FIGURE R804.3.3.4(1)
JACK RAFTER CONNECTION AT EAVE

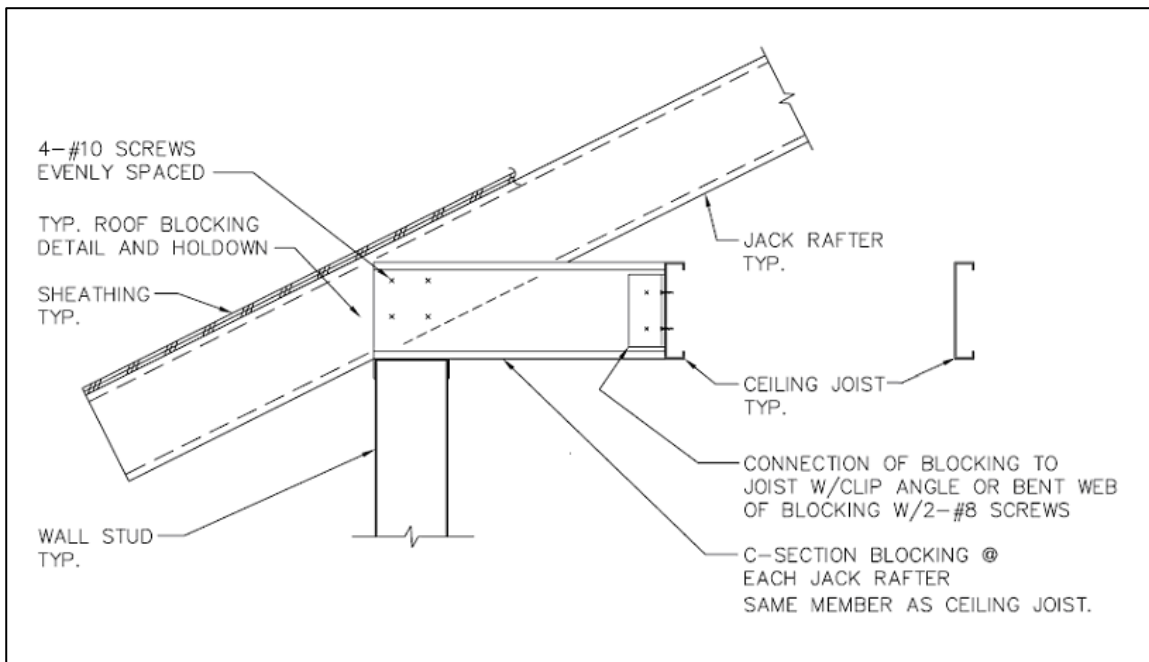
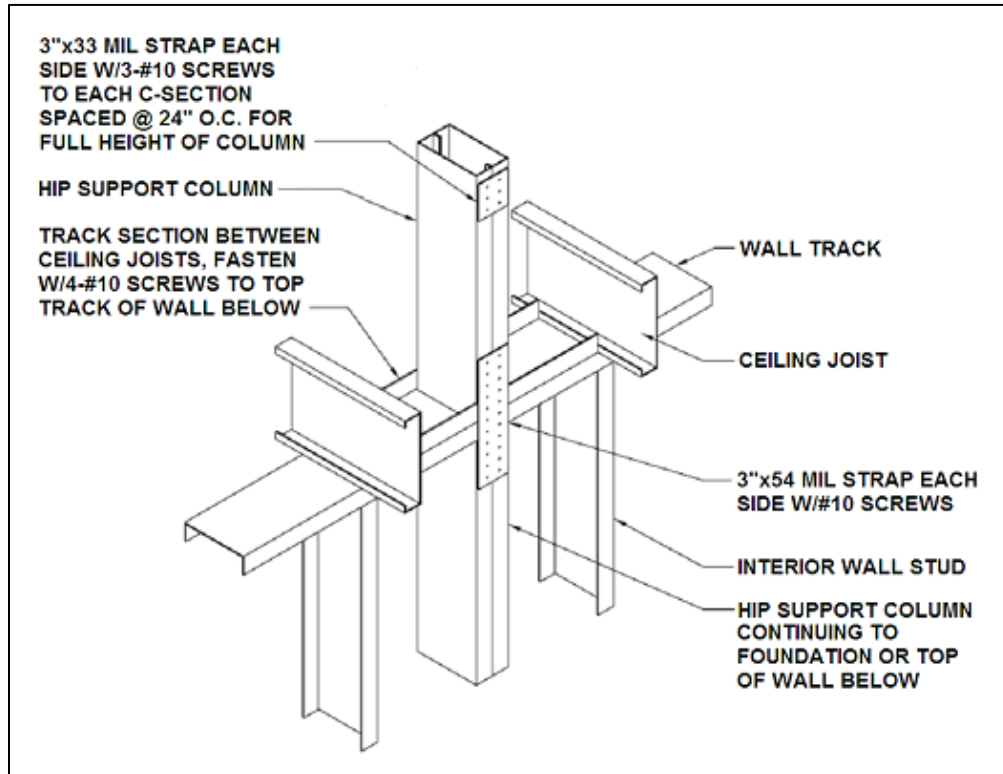
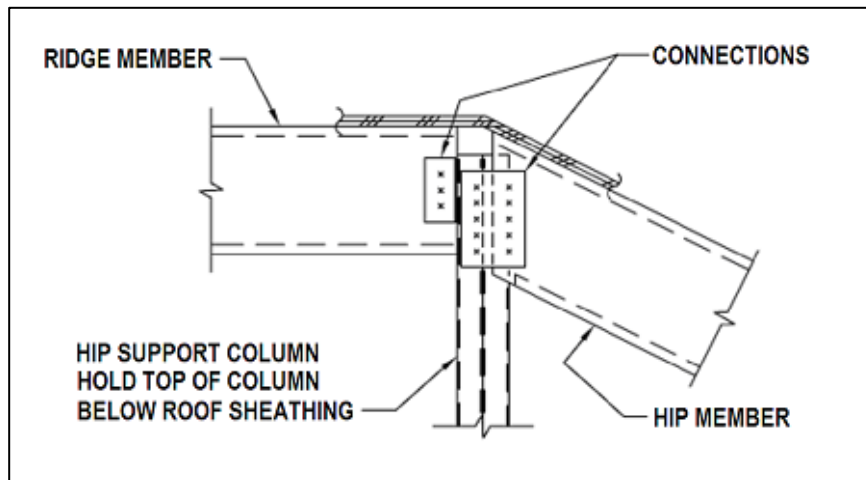
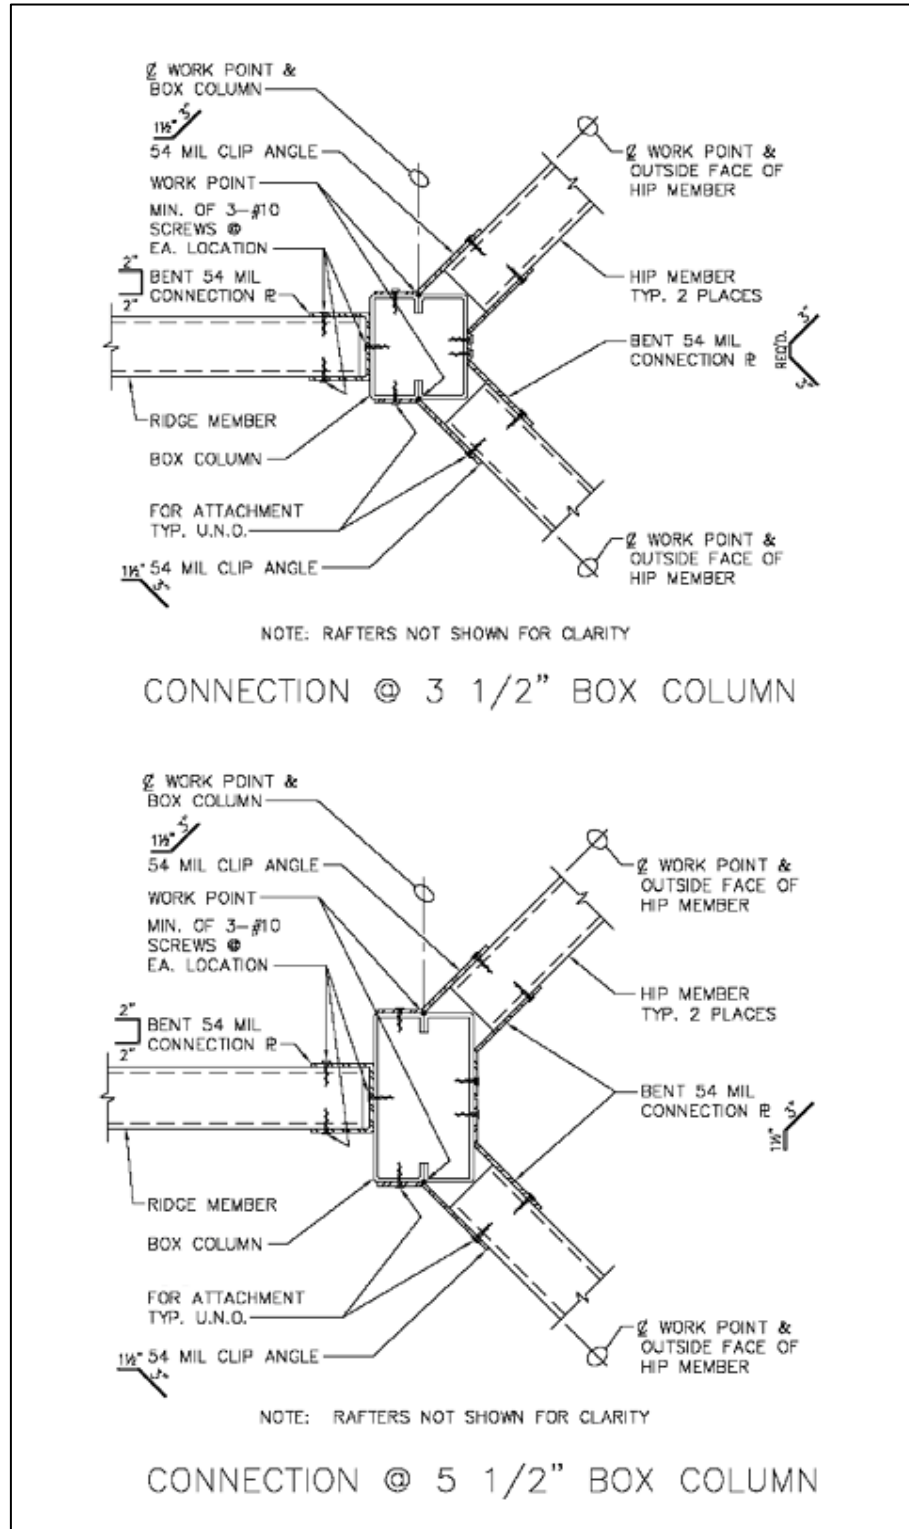
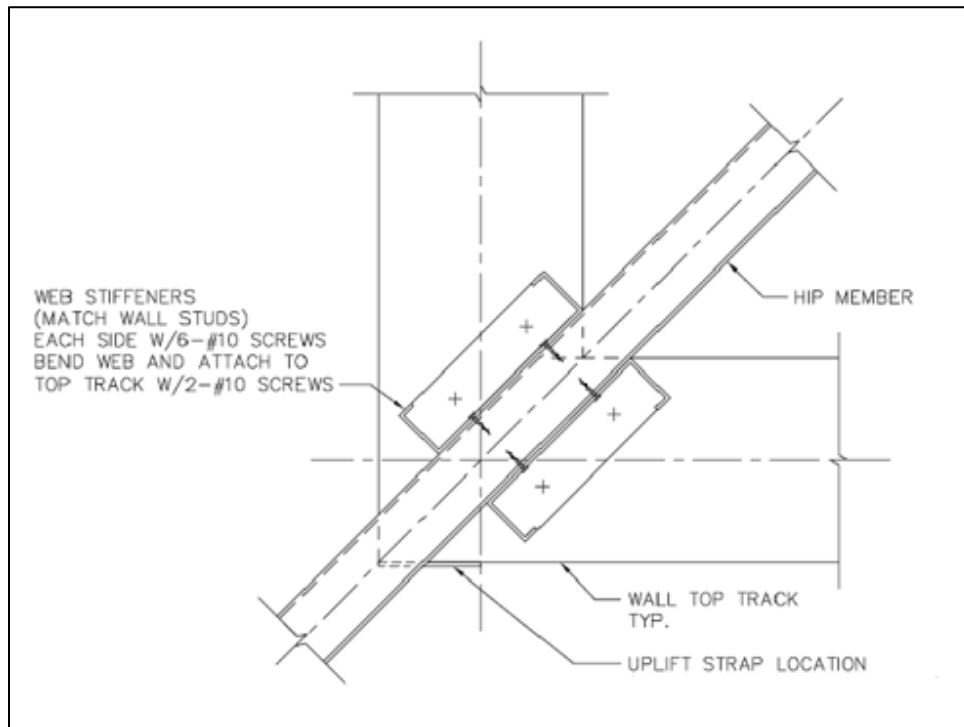
30. Add new figures as follows:

Section R804.3.3: Cold-formed steel hip framing has been added to this section to cover a topic not previously addressed in the IRC. Although this topic is considered common practice and has been available to users through the AISI Prescriptive method in the past, the industry felt it time to integrate these provisions into the IRC to complete the prescriptive requirements in the roofing section. Along with provisions, this proposal also includes tables for framing member and fastening requirements, and includes figures demonstrating the various connections details.

FIGURE R804.3.6(2)
HEADER TO TRIMMER CONNECTION

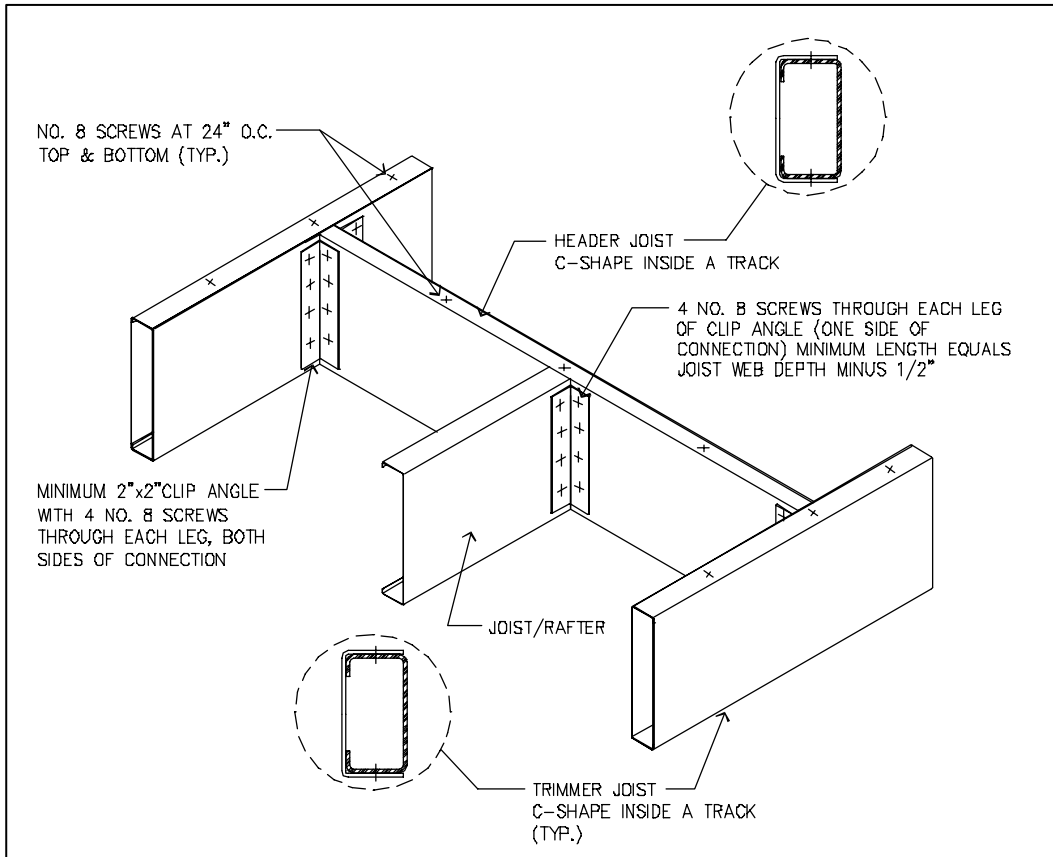
33. Delete existing Figure R804.3.10(2) and substitute as follows:

Section R804.3.6 (new): This section on framing of openings has been updated to reflect the latest provisions from AISI S230, including the addition of a new figure.

FIGURE R804.3.8(1)
CEILING DIAPHRAGM TO GABLE ENDWALL DETAIL

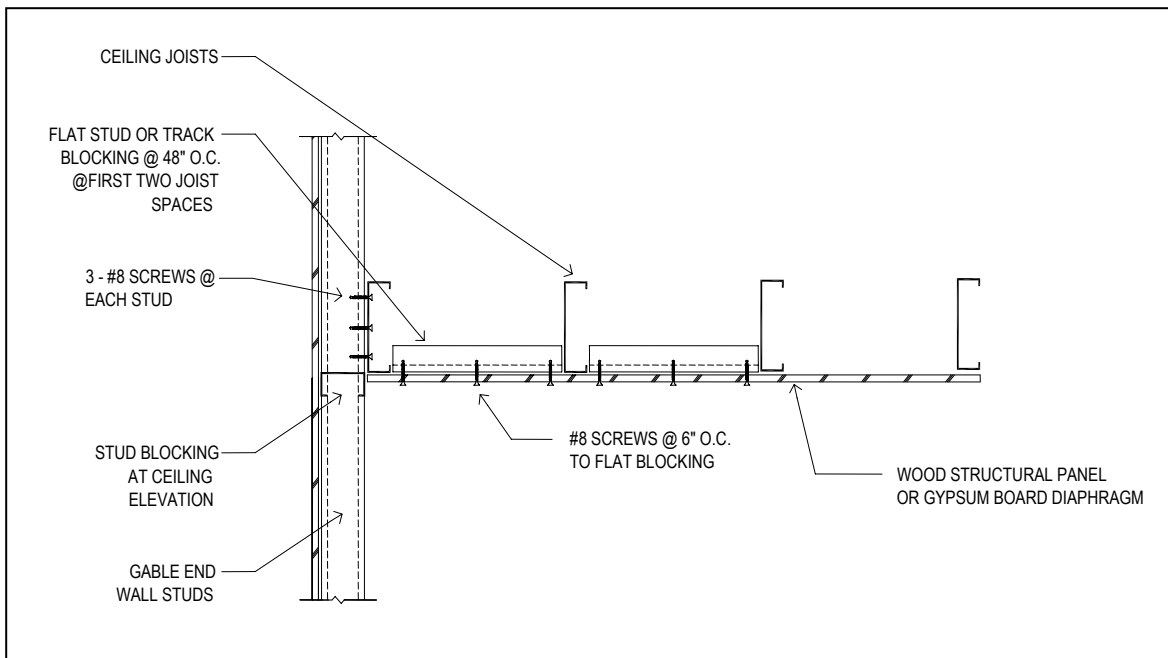
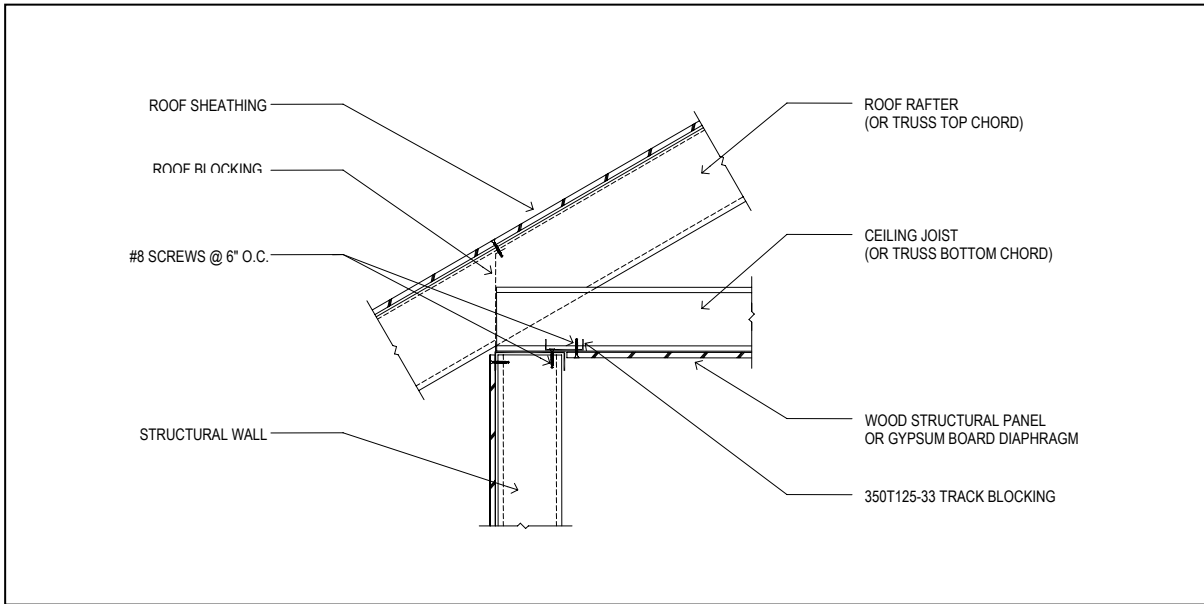
34. Add new figures as follows:

New Section R804.3.8: This new section specifies requirements for the installation of ceiling diaphragms, such as gypsum board and wood panel sheathing. The provisions provide for both the generic prescriptive approach and an approach where, if other installation measures are applied, a reduction in the panel sizes is permitted. Additional tables and figures were added to correspond with the text provisions.
